**CITY OF TEMPE  
DEVELOPMENT REVIEW COMMISSION**

Meeting Date: 06/09/2015  
Agenda Item: 6

**ACTION:** Request for a Development Plan Review, a Use Permit to allow a car wash and a Use Permit to allow more parking than the allowed maximum parking for SUPERSTAR EXPRESS CARWASH, located at 1325 West Warner Road. The applicant is John Reddell of John Reddell Architects.

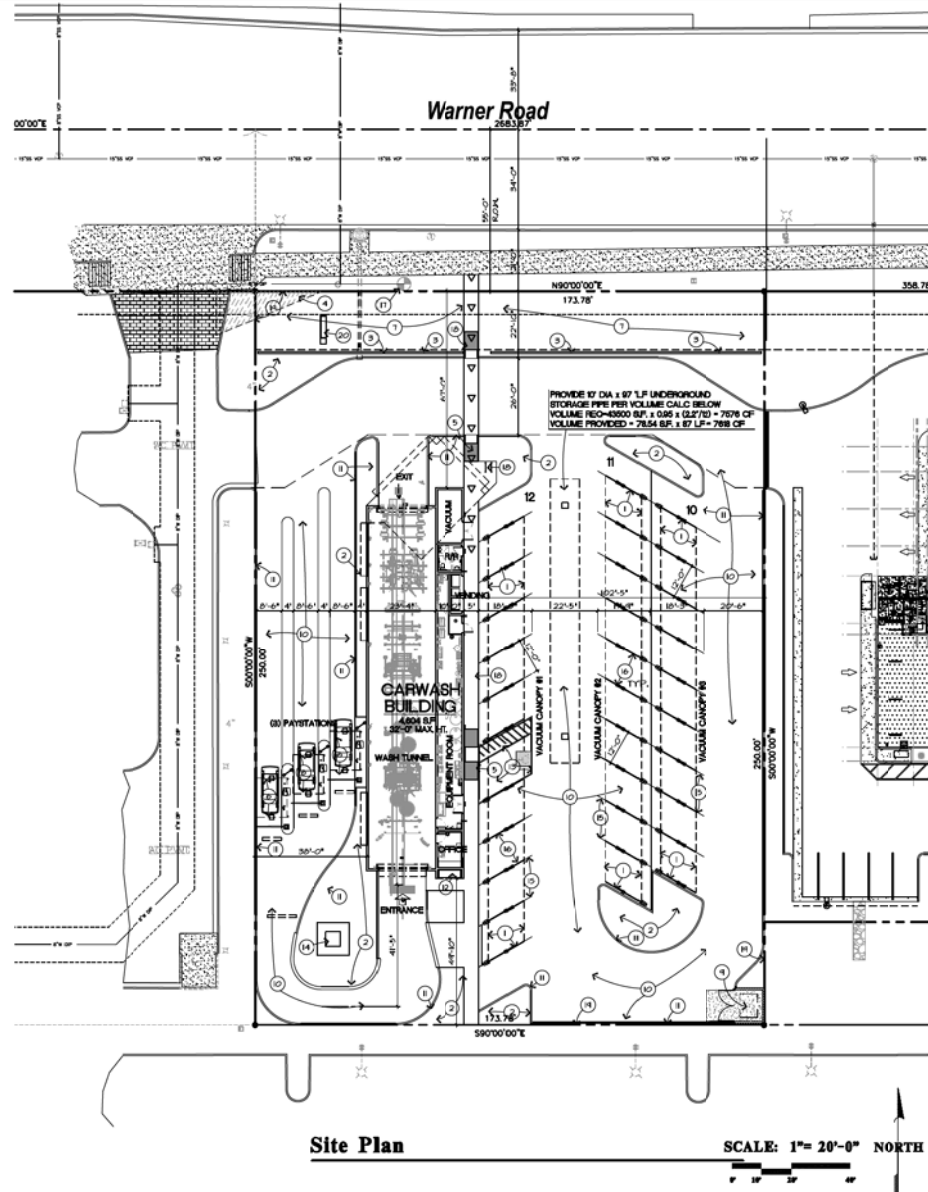
The site is approximately 174 feet wide along Warner Road, and is accessed by off-site driveways on adjacent parcels to the east and west of the property. The building is set back 72 feet from the property line, with a minimum of 20 feet of on site landscape material in addition to the right of way. The lot is 250 feet deep, and shares retention with the lot to the east. Entering the site from the west leads directly into the queue for the three lines leading to the single car wash, patrons stay in the vehicle through the wash inside the bay. Exiting the carwash, guests may park at one of 33 covered parking spaces that have custom designed vacuum canopies to detail the inside of their vehicles by hand. A pedestrian path is provided from the street front to the building, where a small vending room is located with bottled drinks and packaged items.

5. The site plan is approved as submitted (May 18, 2015), minor modifications may be reviewed through the plan check process of construction documents; major modifications will require submittal of a Development Plan Review.

6. Provide 8'-0" wide public sidewalk along arterial roadways as required by Traffic Engineering Design Criteria and Standard Details.
7. Provide service yard and mechanical yard walls that are at least 8'-0" tall as measured from adjacent grade and are at least the height of the equipment being enclosed, whichever is greater. Verify height of equipment and mounting base to ensure that wall height is adequate to fully screen the equipment. Locate electrical service entrance sections inside the service yard, as indicated.

11. Shade canopies for parking areas:
  - a. Canopy structure shall be red in color as presented, canopy fabric shall be beige to match building.
  - b. Conceal lighting and conduit in the canopy structure, no exposed conduit.

**BUILDING ELEVATIONS**

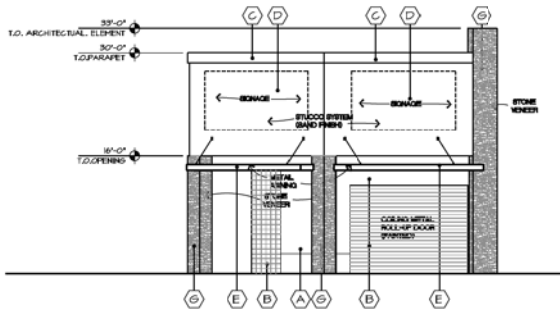
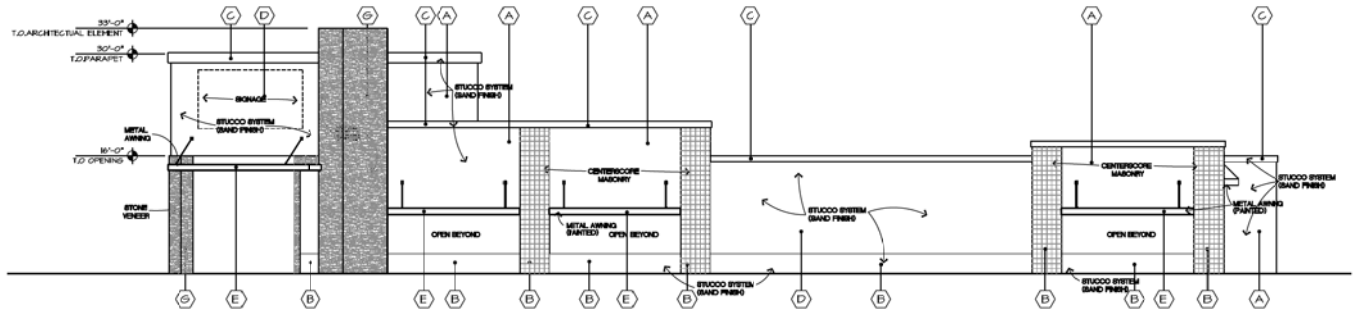
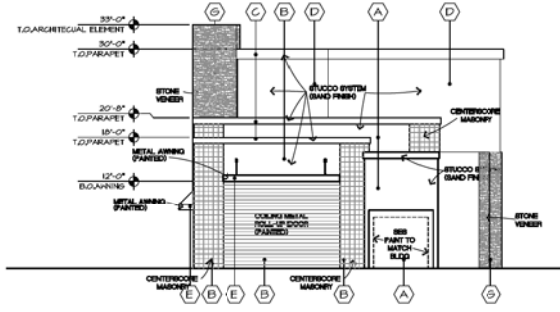
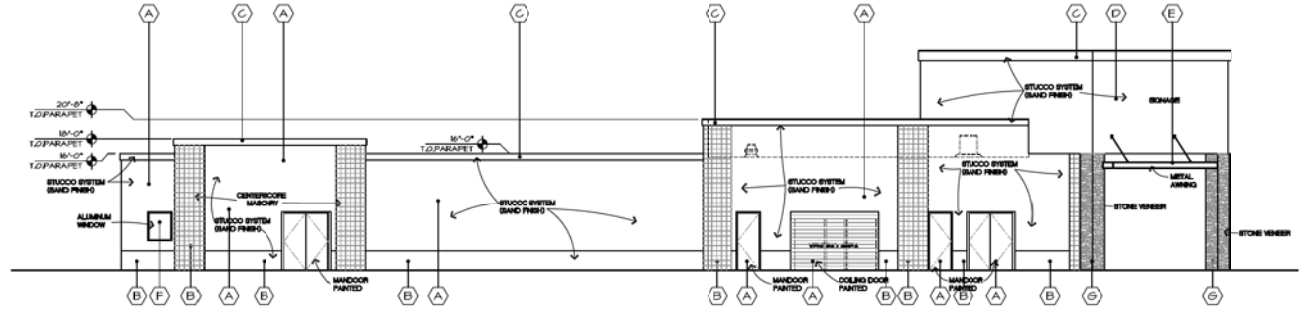
The building is 21 feet wide facing Warner Road, and 132 feet deep on the east and west elevations. The north and south ends have one 12 foot tall bay door, with a building height of 30 feet and an architectural tower extending to 33 feet. The maximum height allowed is 35 feet measured from top of curb. The front north elevation has a faux stacked stone column

projection with a sign band that extends like a canopy to the north of the bay door façade, recessing the door visually from view. The bay door is screened from the street by a 3' screen wall and additional landscape material. The stacked stone columns wrap the building with a textural change. An integral colored split faced masonry wainscot along the east and west sides ties the building materials to the oil service center to the east. The corporate colors are red and gold for this product, however, the architecture cannot be used as signage for the company. Since red was used on the adjacent oil service center, a red accent was used on the metal awnings and the structural supports of the vacuum canopies. The primary building color is neutral painted beige stucco, however, the color elevations have four paint colors listed, which seems excessive for a small building. Conditions have been added to address the colors and materials of the building. The canopies were to be a neutral fabric, this has also been conditioned. The canopies have built in LED lighting on the underside of the structures. The bay door is secured with a painted metal roll down door at night. The east and west elevations have large windows with views into the wash bay. Building awnings provide shade over the entry and exit, as well as over windows and pedestrian doors.

12. The materials and colors are approved as presented (May 27,2015) and modified by condition:
  - Roof – flat with parapet
  - Primary Building - Color A – Stucco painted Dunn Edwards Almond Latte DE6143 (beige) is to be used on all four sides of the building as the primary color.

- Secondary Building - Color D – Stucco painted Dunn Edwards Salt Box DE6141 (cream) is to be used only on the tallest building element at the front of the building, not on the east and west sides of the building.

- Wainscot – Color K – Split Faced Integral Colored CMU Superlite Block Tierra Brown, standard size running bond pattern
  - Columns - Color B – Smooth Faced CMU square stacked block to be integral colored, to match Dunn Edwards Teddy Bear DE6131 (tan) –cmu is not to be painted

- Building Trim - Color C - Painted Dunn Edwards Old Boot DE6133 (dark tan)
  - Metal Awnings – Color E – painted metal building canopies Vacutech Red (bright red)

- Structural supports of shade canopies – Color J – Powder Coated Vacutech Red (bright red)
  - Shade Canopy Fabric – Color H – Shall be beige to match primary building color A

preliminary landscape plan

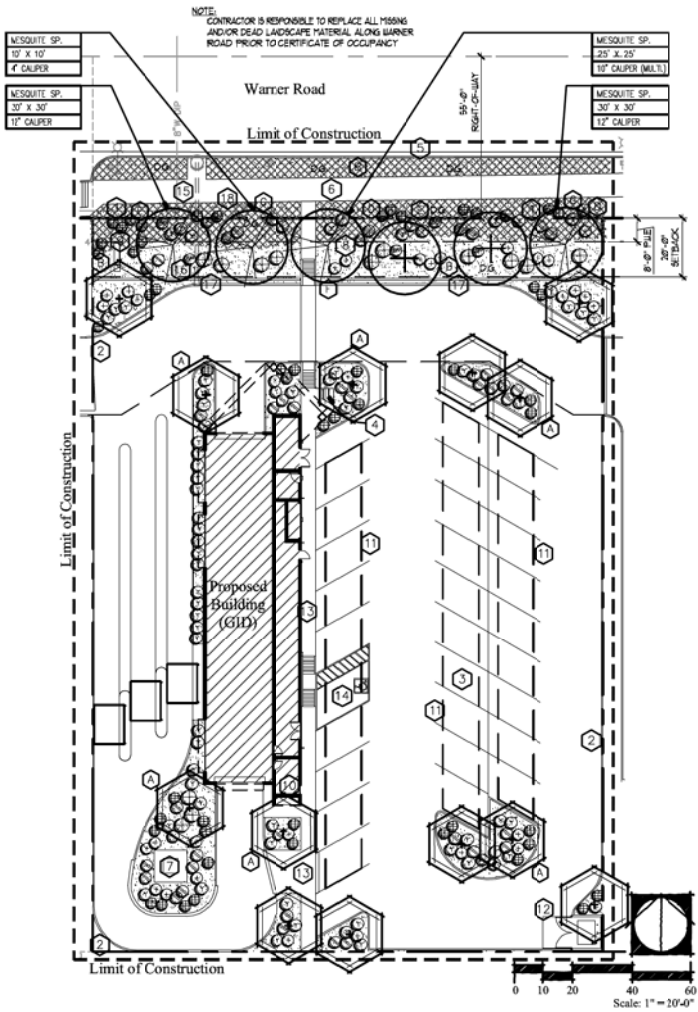
The site is landscaped along the street frontage with existing mature trees, however a condition has been added to use more street front vegetation where the landscape plan indicates "existing landscape area", since this area has a few Red Yucca but no other vegetation on the north side of the sidewalk, and limited plantings south of the sidewalk. This area needs enhancement from what is existing and what is proposed. Willow Acacias are used around the building and the shade canopies where the vacuum stations are located. Shrubs include Pink Fairyduster, Baja Ruellia, Bird of Paradise, Red Yucca, Desert Spoon and Gold Lantana. Additional landscape is needed directly in front of the bay, and has been conditioned to meet screening requirements.

19. The plant palette is approved as proposed and specified on the landscape plan. With the following modifications:
  - a. Street front vegetation north of the sidewalk shall include Ruellia Katie, Dwarf Muhlenbergia, and Gold Lantana to a minimum landscape coverage of 30% of the ground area.

- b. Arterial street trees shall be a minimum of 36" box specimens and a minimum of 1 ½" caliper trunk.
  - c. Two 15-gallon Arizona Yellow Bells and four 5-gallon Green Cloud Texas Ranger Sage shall be planted north of the entry bay, in the street front landscape area to screen the service bay door.

- d. Vegetation shall be maintained in a natural form, allowed to grow to natural heights and not be sheared for visibility.
  - e. Any additions or modifications may be submitted for review during building plan check process.
